Access Compliance Report

Public Rights-of-Way

(Curb Ramps)

Intersection ID: 44448	Main Street: BAYVIEW_PY	Cross Street: NEWFIELD_ST	Location: SE
ADA ID: 4B51CADA4A94	Ramp Type: BlendTrans1	Initial Pass/Fail: Fail	Overall Compliance: No
Severity Score: 8.75			
Codes/Mitigation Info/Possible Solution		Field Measurements/Component Compliance

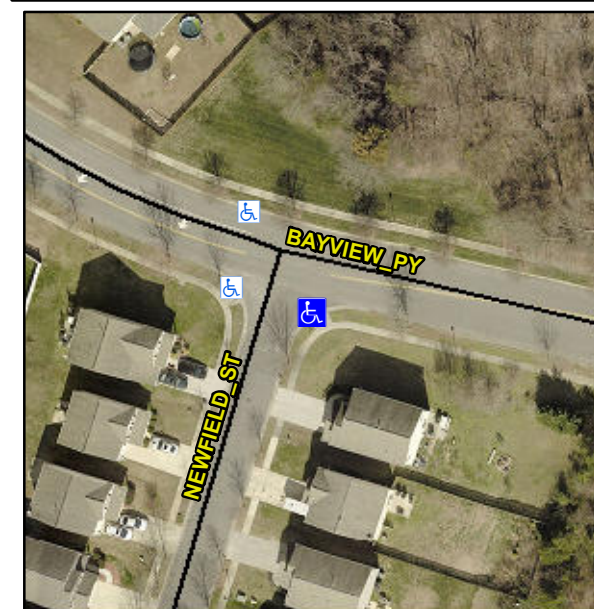
Not Found, R304.5.1

Compliance	Description	Data	Compliance	Description	Data
N/A	Ramp Length (in)	78.0	Yes	BlendTrans Slope (%)	2.7
No	Ramp Width (in)	47.0	Yes	BlendTrans XSlope (%)	1.2
N/A	Flare Type LT	N/A	N/A	Flare Type RT	N/A
N/A	Flare Slope LT (%)	N/A	N/A	Flare Slope RT (%)	N/A
N/A	Flare Traversable LT?	N/A	N/A	Flare Traversable RT?	N/A
N/A	Landing Length (in)	N/A	N/A	DWS Provided?	N/A
N/A	Landing Width (in)	N/A	N/A	DWS Contrast?	N/A
N/A	Landing Slope (%)	N/A	N/A	DWS Length (in)	N/A
N/A	Landing X Slope (%)	N/A	N/A	DWS Full Width?	N/A
N/A	Landing Curb? (Y/N)	N/A	N/A	DWS Offset (in)	N/A
N/A	Shared Landing?	N/A			
N/A	Gutter Ponding?	N/A	N/A	Gutter Slope (%)	N/A
N/A	Gutter Lip Ht (in)	N/A	N/A	Gutter X Slope (%)	N/A
N/A	Painted X Walk1?	No	N/A	Painted X Walk2?	No
	X Walk 1 Direction	To N		X Walk 2 Direction	To W
	X Walk 1 Width (in)	N/A		X Walk 2 Width (in)	N/A
	X Walk 1 Slope (%)	0.5		X Walk 2 Slope (%)	2.0
	X Walk 1 X Slope (%)	2.4		X Walk 2 X Slope (%)	2.2

N/A	Ramp inside XWalk1?	N/A	N/A	Ramp inside XWalk2?	N/A
	Road Slope (%)	2.7		Clear Space?	N/A
	Road X Slope (%)	3.0	N/A	Clear Space to XWalk (in)	N/A
N/A	Any Obstructions?	N/A	N/A	Storm Grate/Utility Hazard?	N/A
	Obstruction Type			Storm Grate/Utility Type	
		N/A			N/A
			Yes	Surface Condition? (G/P)	Good
			No	Curb Slope (%)	11.4

Remove & Replace Curb Ramp With Two New Directional Ramps or Equivalent.
